Warrenton Planning Commission
AGENDA

- Applicant: Ryan Osburn, Osburn Plumbing
 - Proposal: Construct new contractor shop, warehouse, and office with private street access to SE Dolphin Ave

TO: Warrenton Planning Commission
FROM: Mark Barnes, Interim Planning Director
RE: Osburn Plumbing Site Design Review (SDR20-04); Conditional Use (CUP20-01); and Variance (V20-01)

PRELIMINARY GRADING AND LANDSCAPE PLAN
SCALE: 1" = 30'

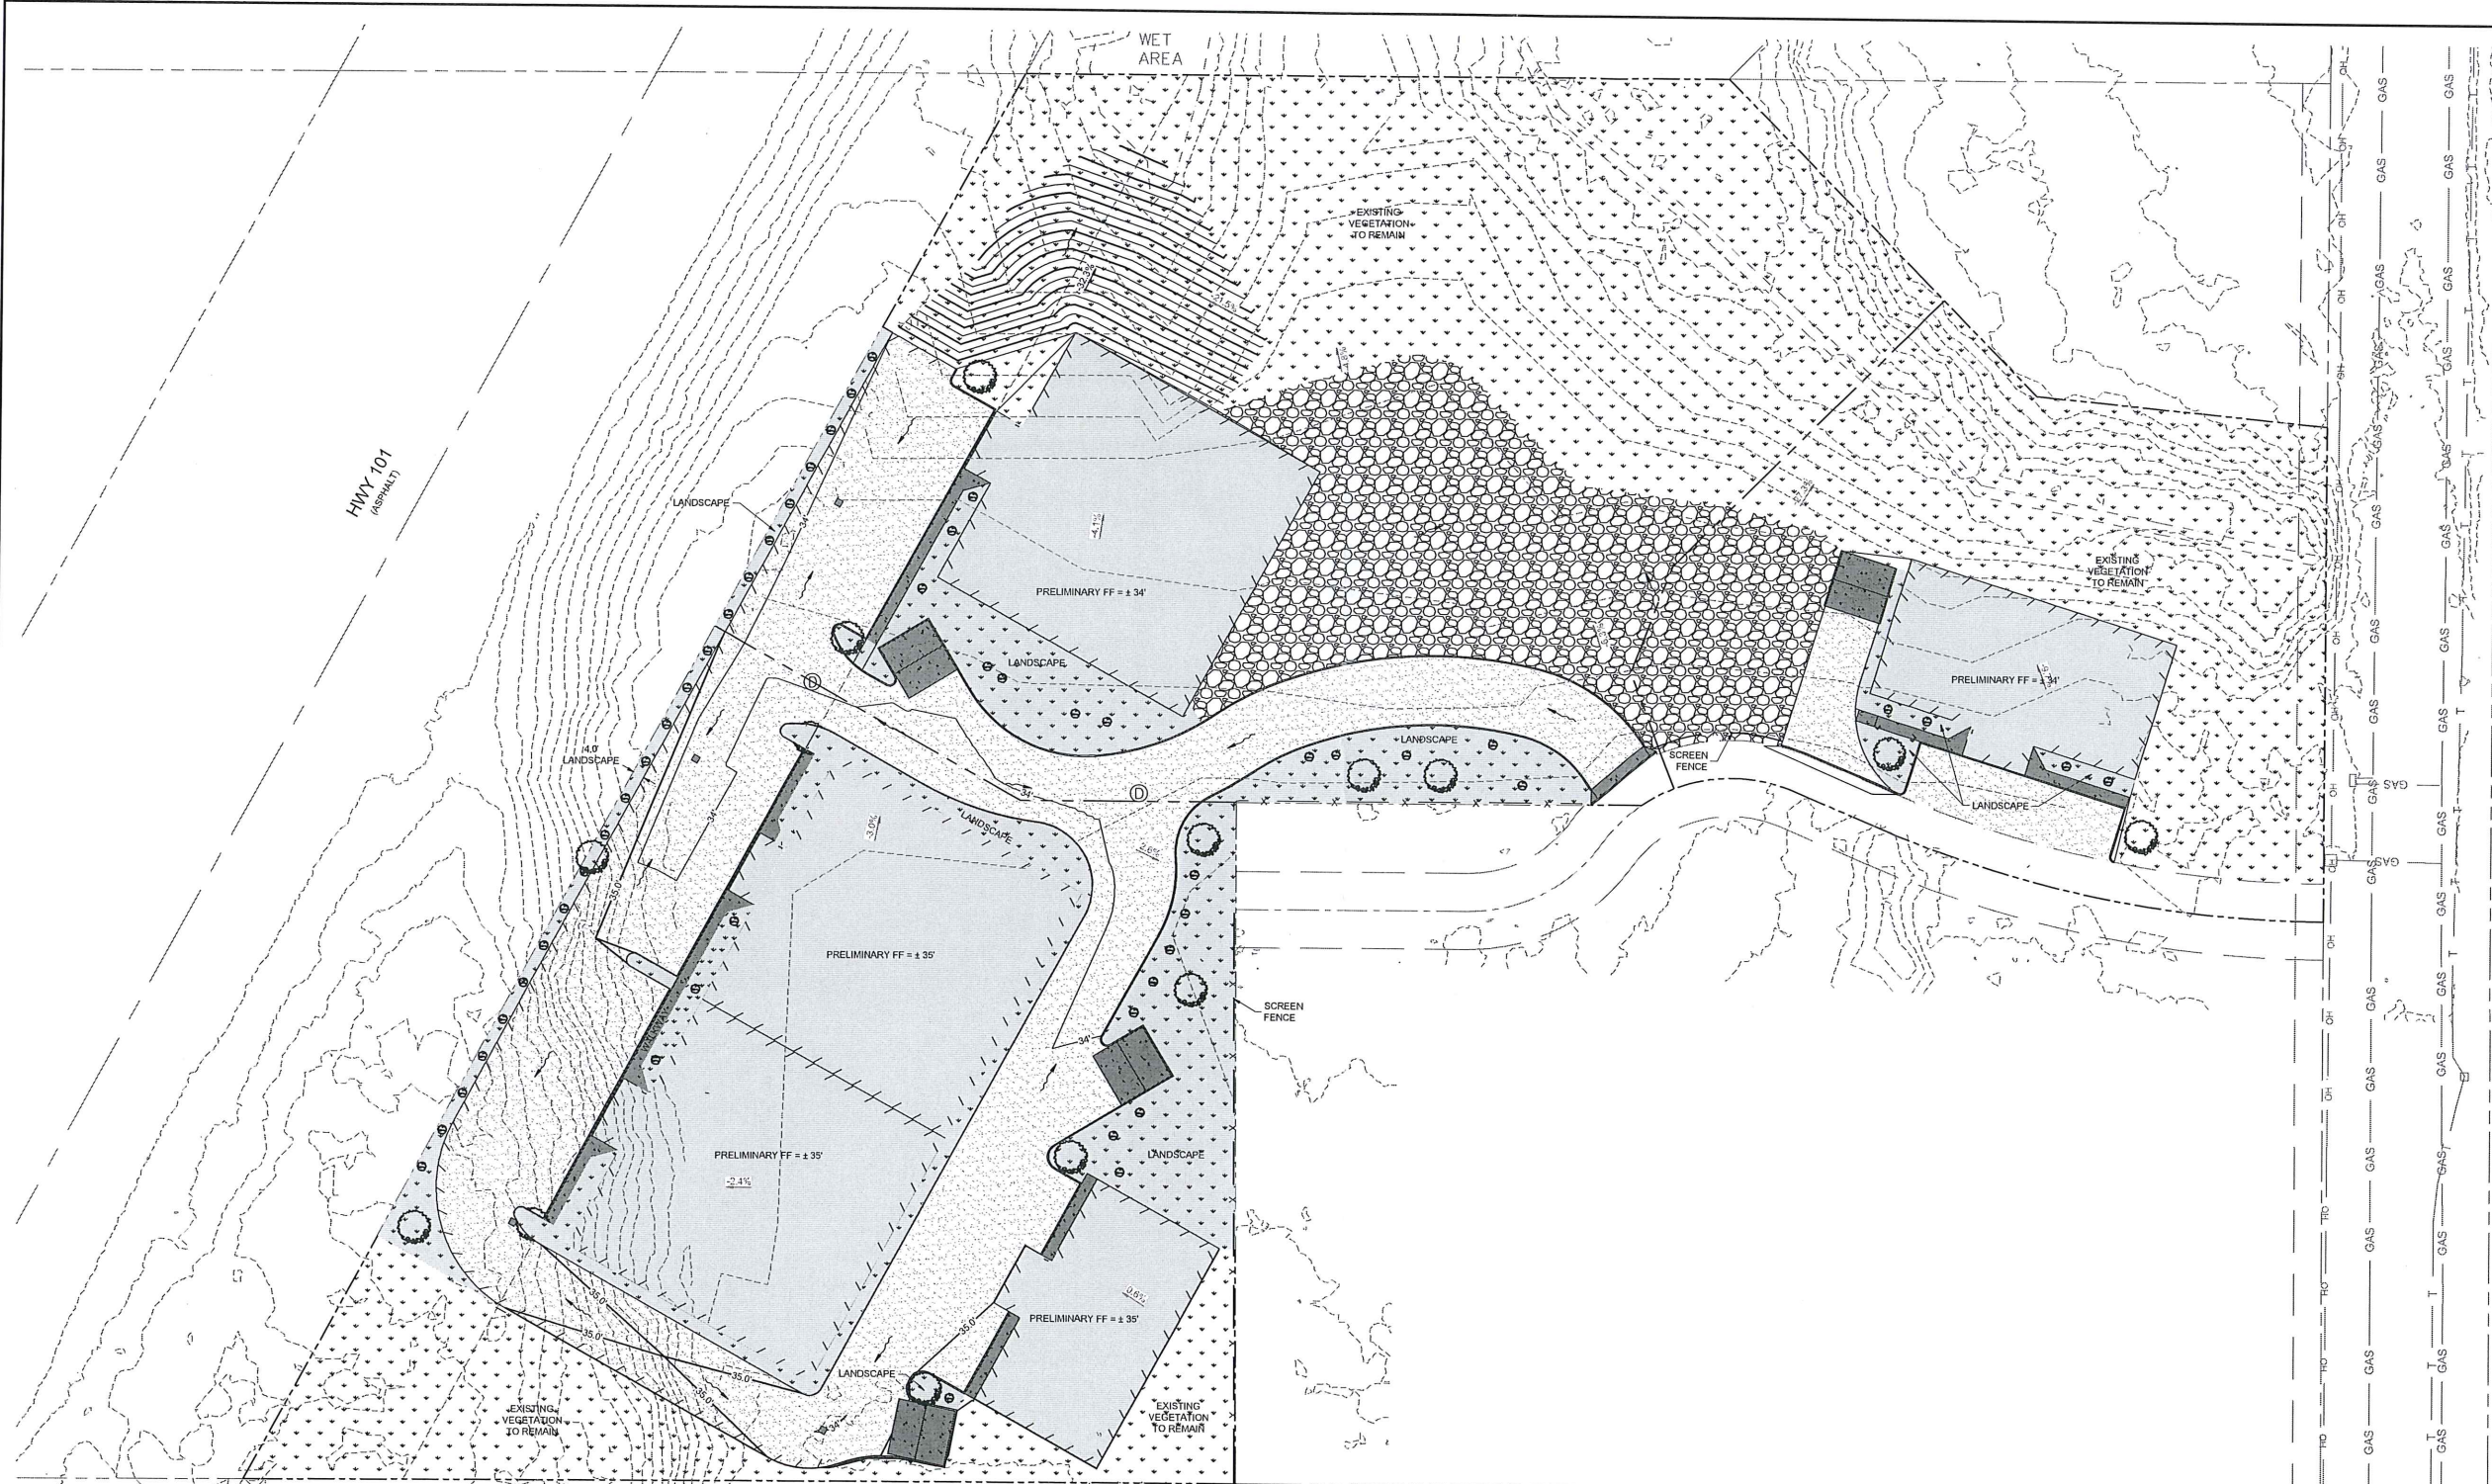
According to figures provided on sheet C4 of the applicant's site plan, the site covers about 194,563 square feet. Proposed new landscaping will cover about 12,622 square feet, or about 6.5 percent of the site. Conserved landscaping covers an additional 76,766 square feet, or about 39.5 percent. As proposed, new landscaped areas plus existing landscaping to be preserved cover more than 35 percent of the site, thus meeting the coverage standard.

A grading plan and permit can be required as a condition of approval. The proposed site plan shows areas where grading and filling will be needed. See conditions of approval.
